SERVICE LETTER 204

8750 Anchor Mount Installation

Aircraft Makes/Model(s):	Float Model(s):		
Cessna 208, 208B	8750	**Compliance:** Optional	**By:** MAS
		Part Number: 1011194	**Approved:** DRH
		Date: 9/23/2026	**Revision:** B

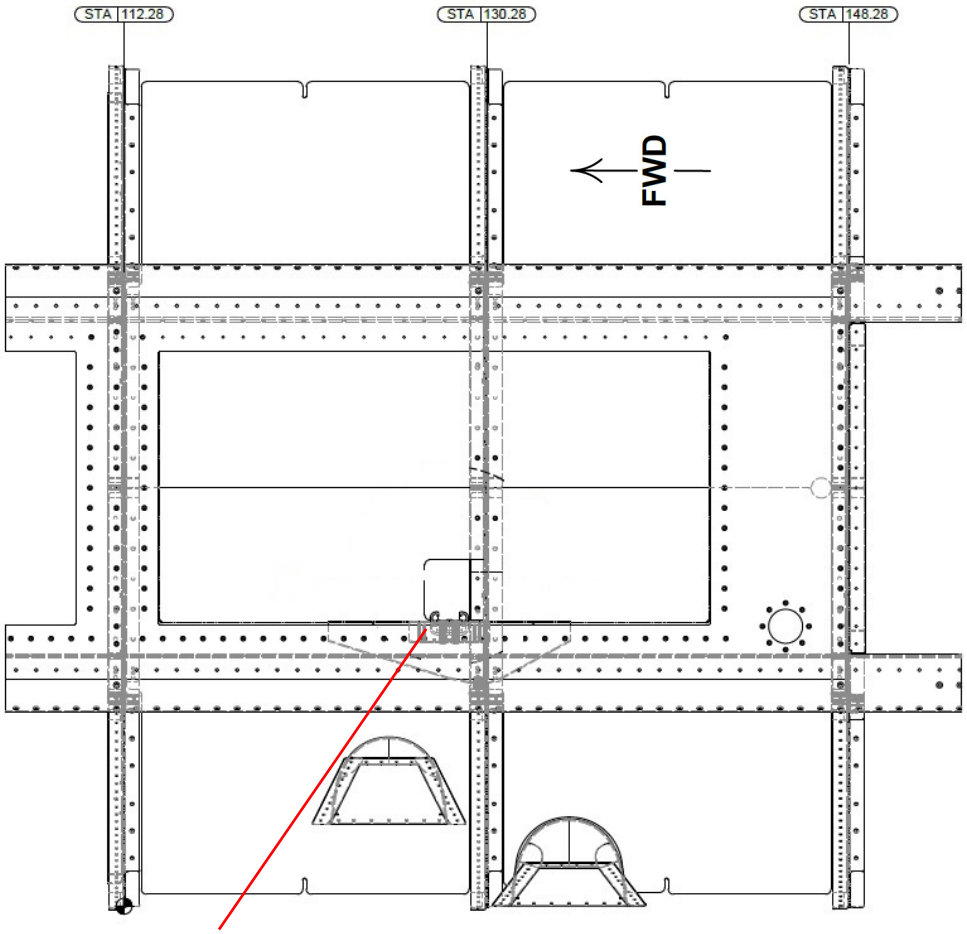
1. Starting with the fifth rivet from the rear of the baggage compartment lip, remove eight rivets and rivet anchor mount assembly to lip.
2. Match drill bottom screw holes in bulkhead flange at bulkhead station 130.28.

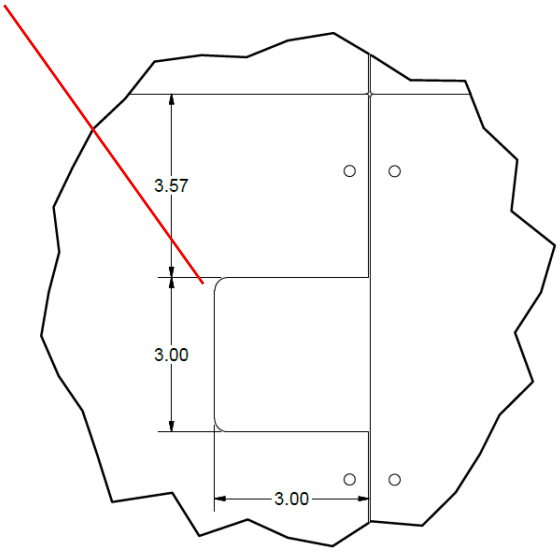
3. Cut out hole in baggage floor as shown.
